**ASHLAND PLANNING DEPARTMENT
PRE-APPLICATION CONFERENCE
COMMENT SHEET**
October 22, 2025

SITE: Iowa Street Tax Lot 500
APPLICANT: Mark Knox-Spartan Properties LLC.
REQUEST: 5-lot PSO Subdivision with seven Units

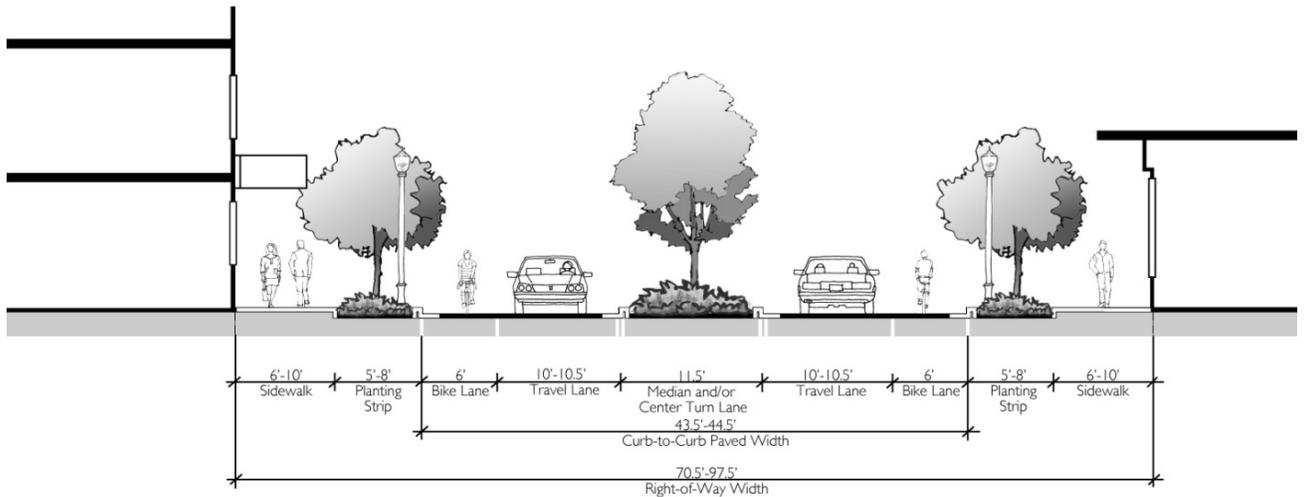
Lot 5 & Driveway Configuration: For staff, the driveway configuration and it's relationship to Lot 5 have potential issues. It's unclear whether a vehicle parked in the ADA space has room to turn and exit to the street in a forward manner, which is a requirement for flag drives. The application will need to demonstrate that a functional turning movement is possible to meet this standard. In addition, the driveway directs headlights and vehicle flow directed directly at the unit without the requisite eight-foot landscaped buffer. A buffer will need to be provided or an exception to this standard requested.

Setbacks/Yard Requirements: While standard setbacks do not apply within PSO subdivisions, the underlying setbacks of the parent parcel must be preserved, each lot must provide a front yard consistent with the underlying zoning and building separation must be addressed.
